Access Design Consultancy Report

Civic Link Block 3 Parramatta

**Civic Link Between Phillip Street and
George Street, Parramatta, NSW, 2150**

VBC250154_ADR_DD_01

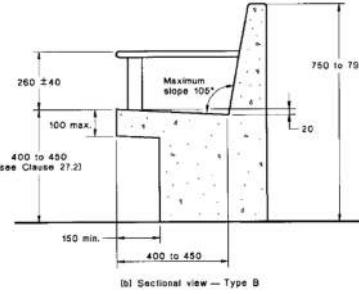
2.	Pedestrian Access - Footpaths	<p>Gradients</p>	<ul style="list-style-type: none"> Gradients vary along the footpaths. Along the paths of travel, the steepest gradient is 1:14. This gradient continues for approximately 10m. Within this area is a resting spot being the link bridge. The link bridges meet the 1:40 gradients and act as places of pause for the site. AS1428.1:2021 – 1:40 gradients are used on landings and therefore are suited for the bridges.

Appendix B – gradient diagram

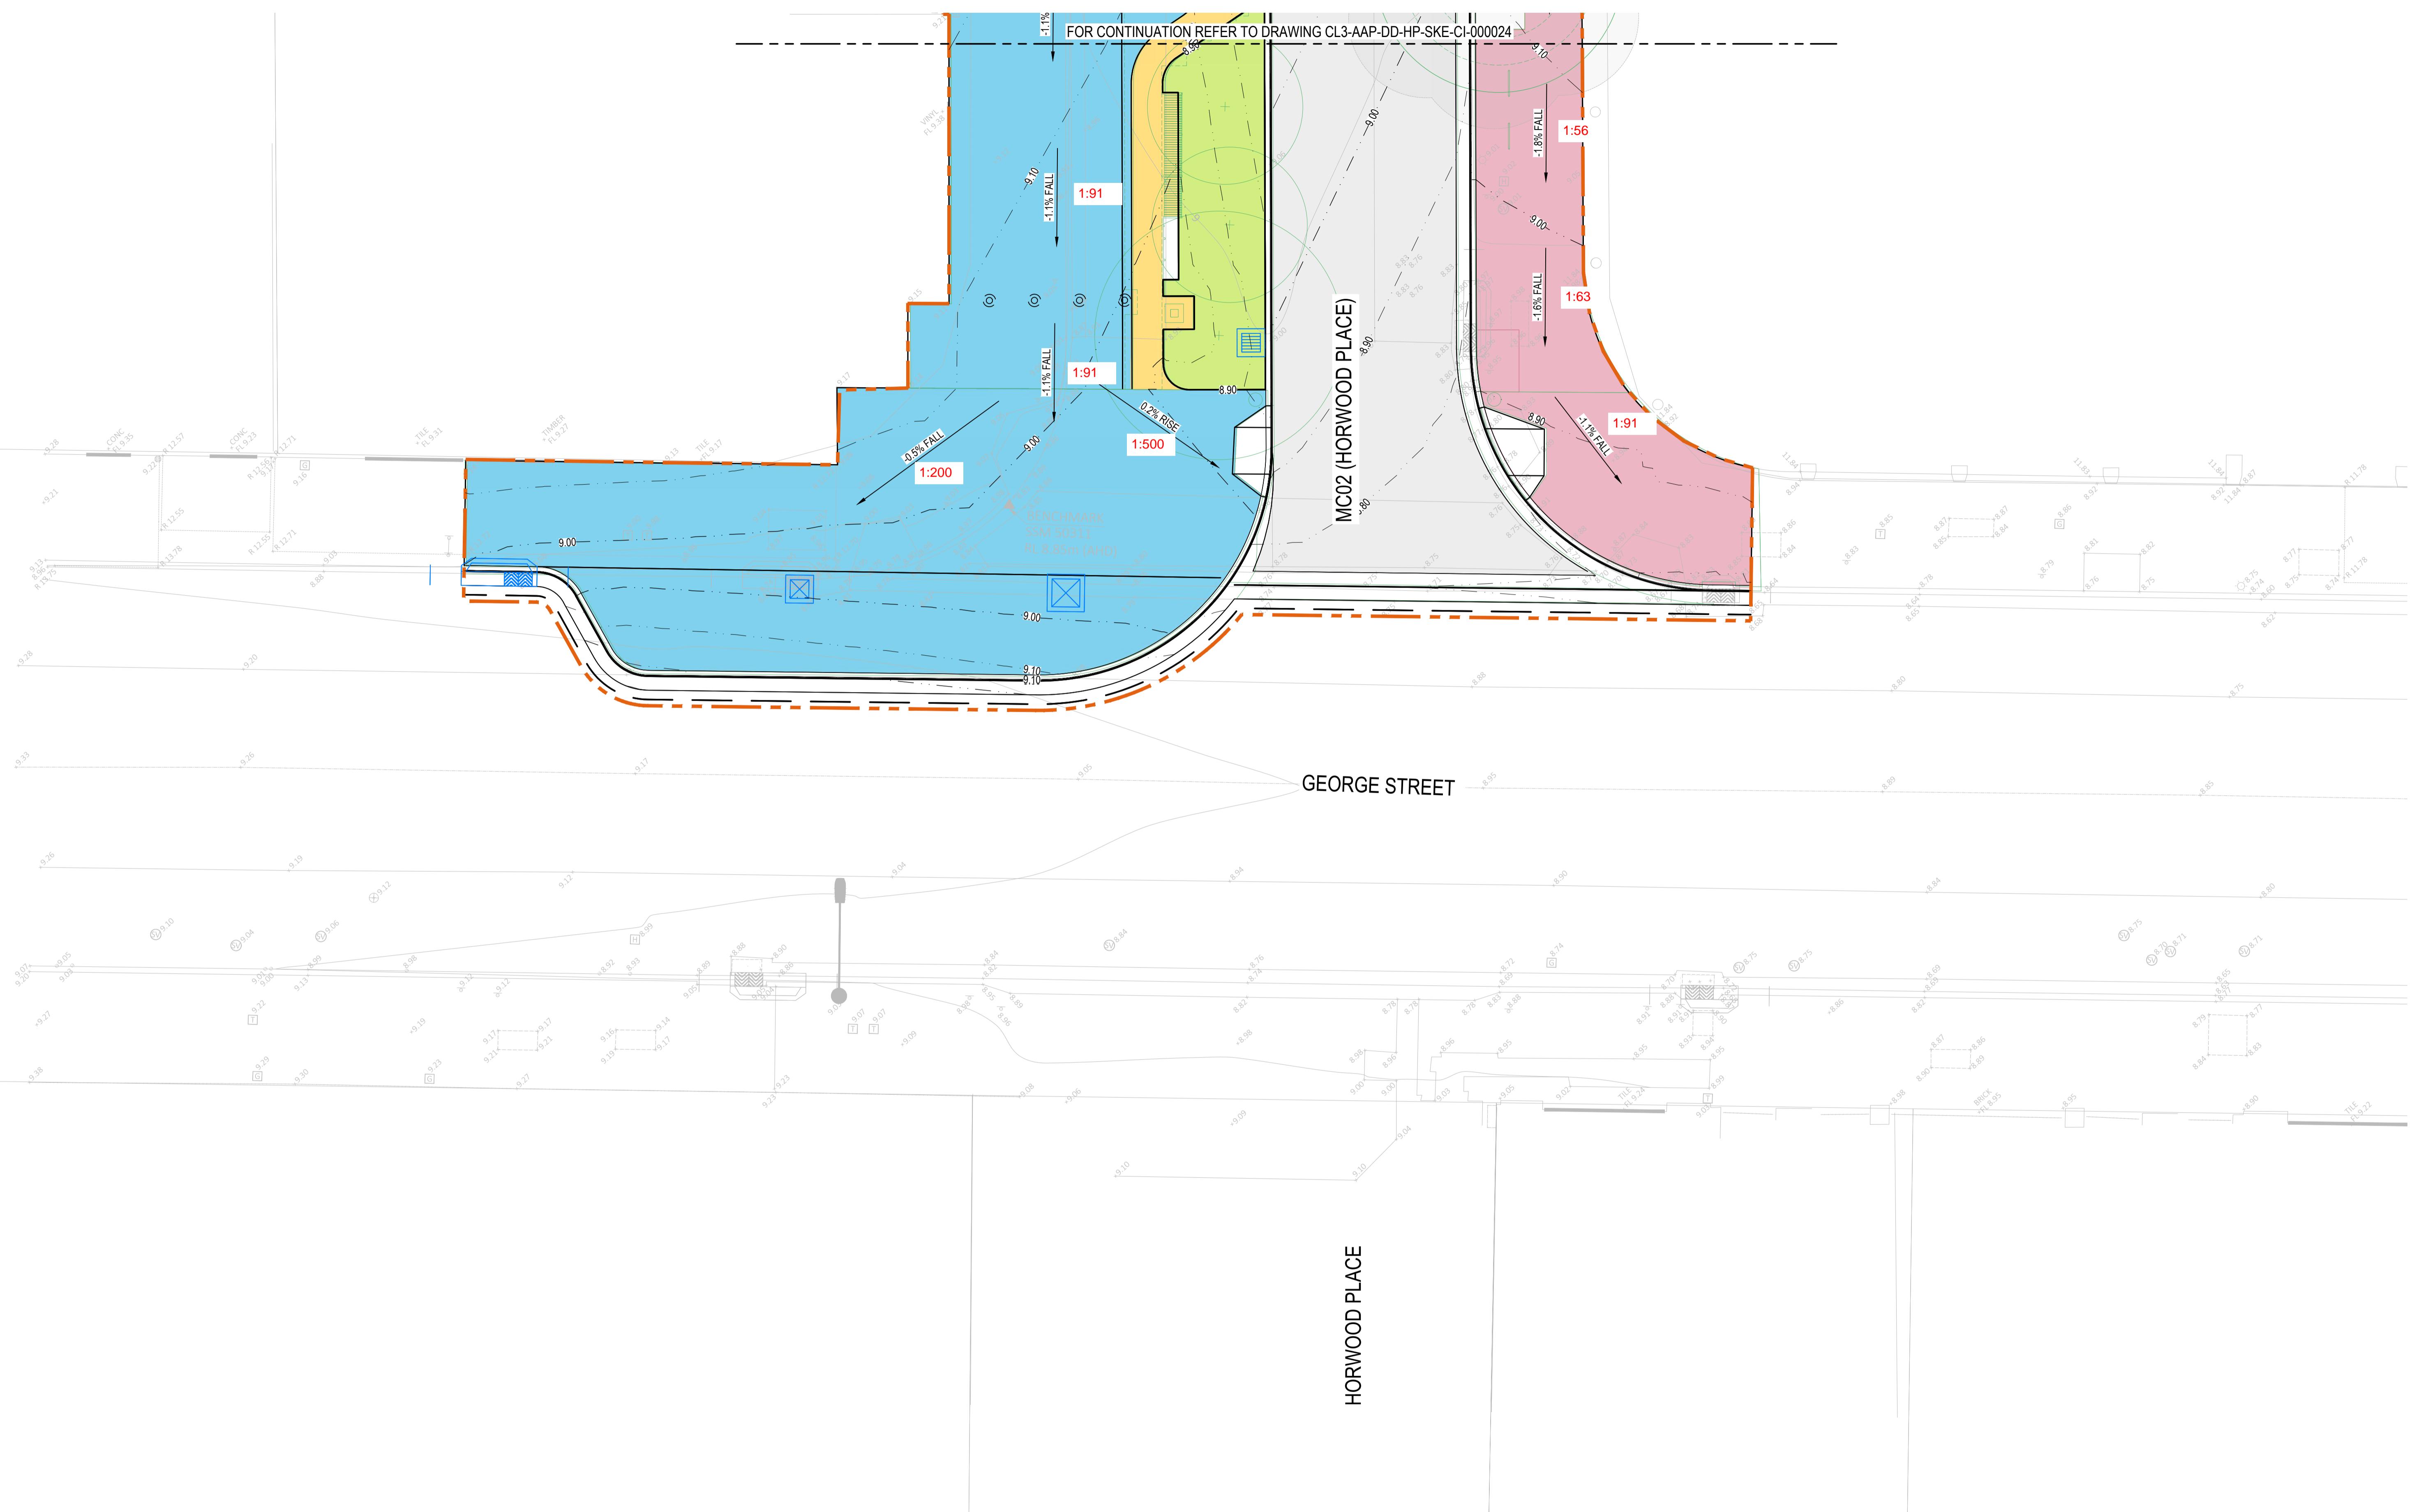
<ul style="list-style-type: none"> • A more generous walkway and cycle path is provided on the western edge of the site with a consistent gradient of 1:19. • Where a 1:19 gradient is provided, it is a manageable gradient whereby a person can still walk independently. <p>For gradient diagram refer to Arcadis Civil drawing Appendix B.</p>
